## CERTIFICATE OF APPROPRIATENESS

**Property:** 1811 Shearn Street, Tract 9, Block 304, Shearn Subdivision. The property includes a historic 880 square foot, one-story wood frame single-family residence and a detached garage situated on a 3,333 square foot (33'-4" x 100') interior lot.

**Proposal:** Alteration – Construct a 1,032 square foot two story addition at the original rear wall of the residence.

**NORTH ELEVATION – FRONT FACING SHEARN STREET**

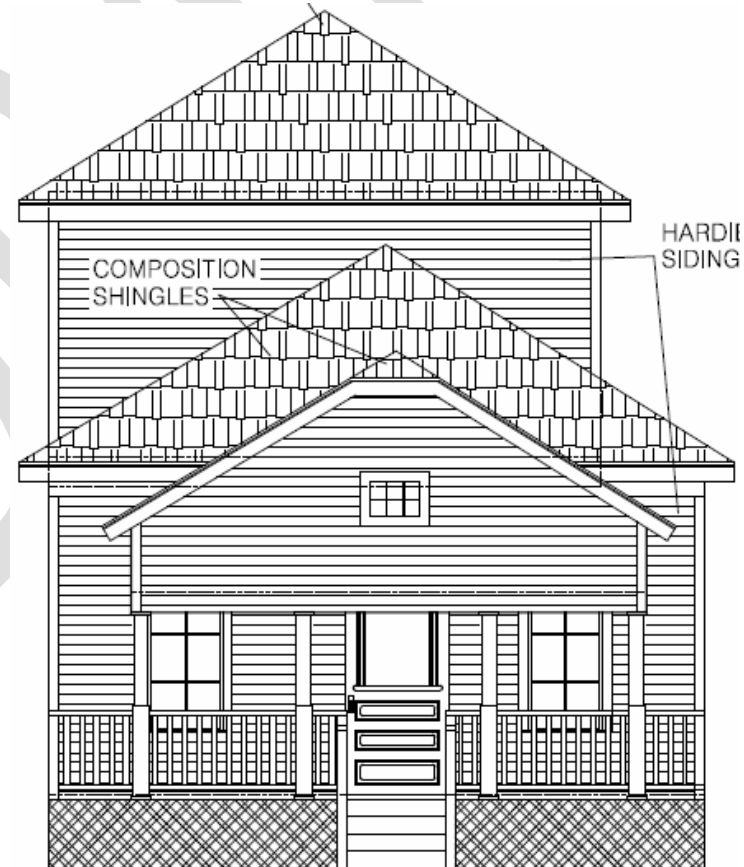
**Front Elevation:** The residence features a non-original carport, non-original front porch shed extension, and non-original front porch side extension to be removed. Existing square wood columns will be removed and replaced with square wood columns on square wood bases. A wood balustrade will be installed. The existing non-original front door will be removed and replaced. Two non-original partial height windows will be removed and replaced with full-height wood windows in the original openings.

WEST SIDE ELEVATION

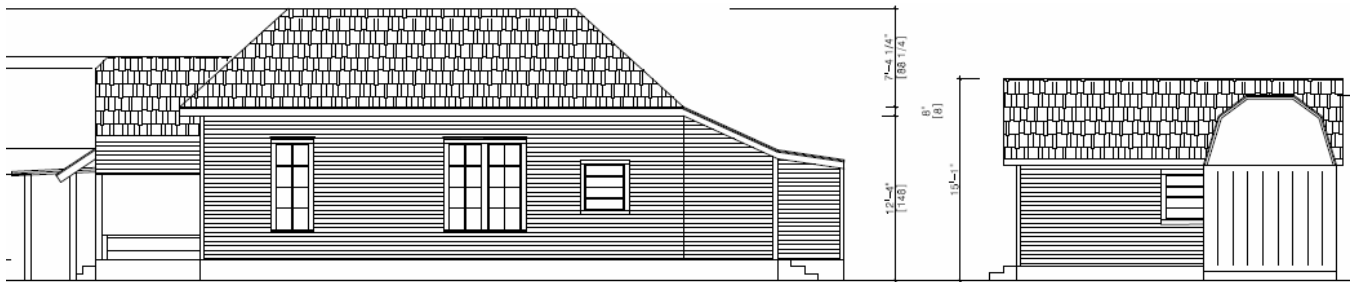
**Side Elevation:** The residence features three original wood windows to be retained. One existing non-original window will be removed and replaced. A new window will be installed in the existing addition, and the proposed second floor will feature three windows.

**EAST SIDE ELEVATION**

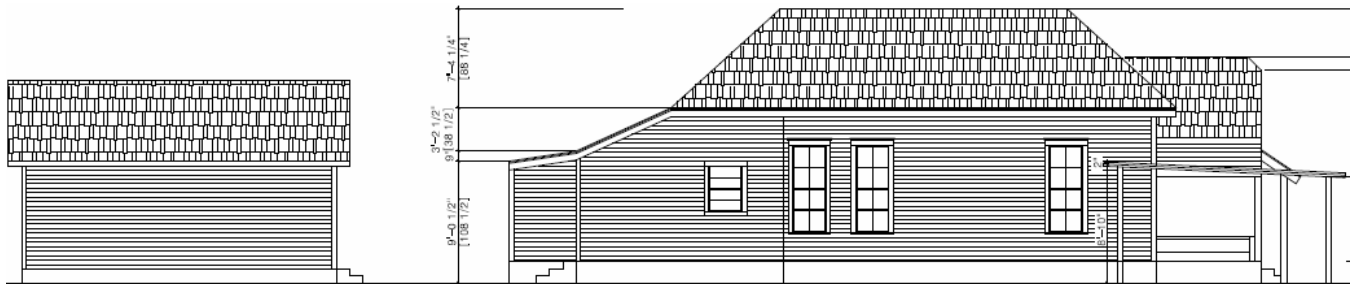
**Side Elevation:** The residence features three original wood windows to be retained. One window in the existing addition will be removed. The proposed addition will feature a door and two windows at the first floor and one window at the second floor.
